PRODUCT CHANGE NOTIFICATION

#PCN-DC-L9VM-14

Business Unit	Product Line Code	Type of Change	Action	Date of issue
DC	ABN	Aesthetic	Notify Distributors and Field	12/10/2014

Previous Product	New Product

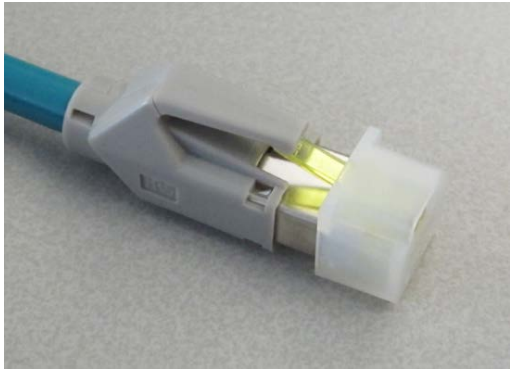
Based on customer requests the listed RJ45 patch cords will now be provided with dust covers. The dust cover is used to protect the RJ45 contacts during shipping and storage.
